**BEFORE THE WAIMAKARIRI DISTRICT
COUNCIL HEARINGS PANEL**

IN THE MATTER of a submission by Andrew
McAllister (submission 8)

REBUTTAL STATEMENT OF EVIDENCE OF ANDREW DAVID CARR

Date: 4 July 2024

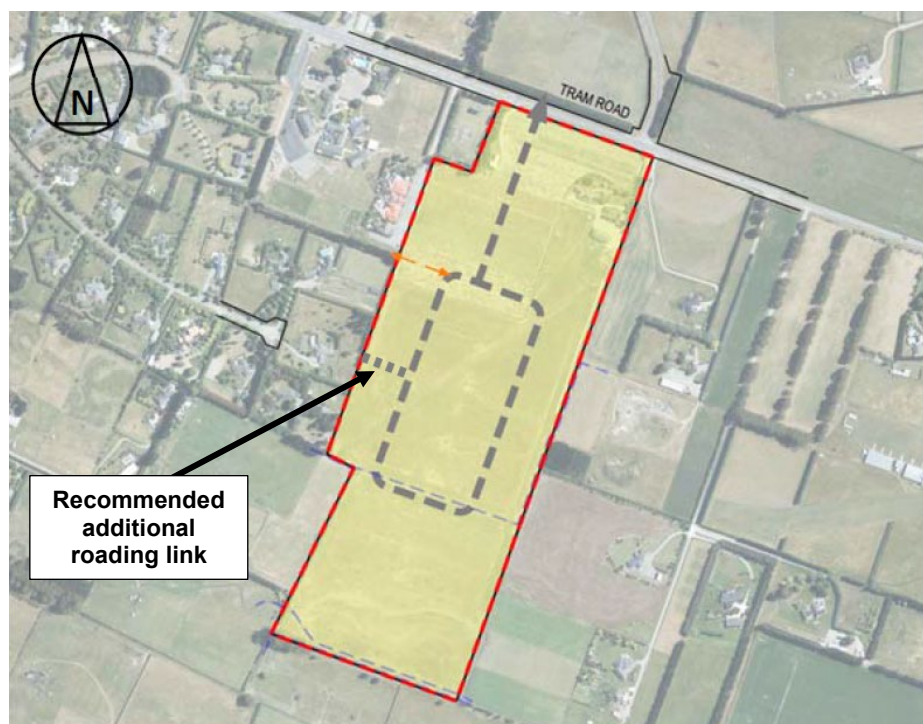
d. Future proof an active travel connection towards Swannanoa.

- Again, this is a topic that is not discussed at all in the substantive part of Mr Gregory's report.
- Block A has frontages onto two roads, both of which have a legal width of 20m. This is ample to accommodate an active travel link. I also note

that there is already an active travel link in place on the southern side of Tram Road, running between Swannanoa School and a connection through to Peacock Place approximately 350m east of Block A.

- I agree the ODP narrative could be updated in this regard to make it clear that such a link is anticipated. The narrative presently states that “*A footpath built in accordance with the Engineering Code of Practice will be provided along the Tram Road frontage*”. I consider that this could be revised to read “*The existing shared walking and cycling route along Tram Road will be extended to the site from its current western termination at the link to Peacock Place*” (although see my comments below regarding a further revision)
